Starter motor mounting, "NC" and "HU" models

3.0 GS

Important Information - Product Failure may Result!

Figure 1

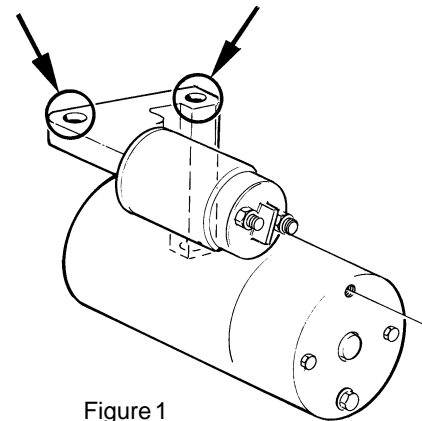
All 3.0 GS models s/n 4110112427 - 4110129759 starter motors should be removed and inspected for cracks. This due to vibration resulting from harmonics at certain RPM. The starter bolts may break and/or the starter housing may crack (figure 1) with extended engine operation at these RPM. If cracks are found, replace starter. Install starter bracket kit 3855672-6, and insure the starter mounting bolts have washers p/n 3854496-1 installed. Torque starter mounting bolts to 40 Nm (29.5 ft.lb).

Figure 2

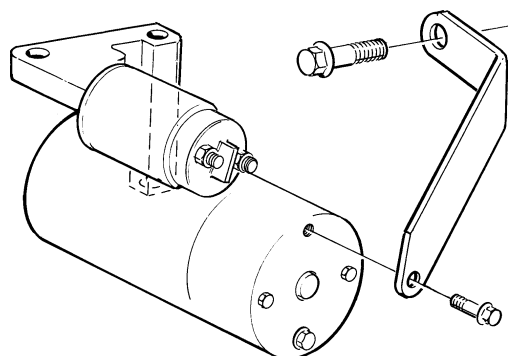
Starter bracket kit p/n 3855672-6 will add a bracket to the upper starter motor housing bolt. The bracket will attach the rear starter motor housing to the cylinder block as illustrated in figure 2. This will prevent premature failure to the bolts and consequent housing damage. Kits can be ordered through Volvo Penta Parts Department in the normal manner.
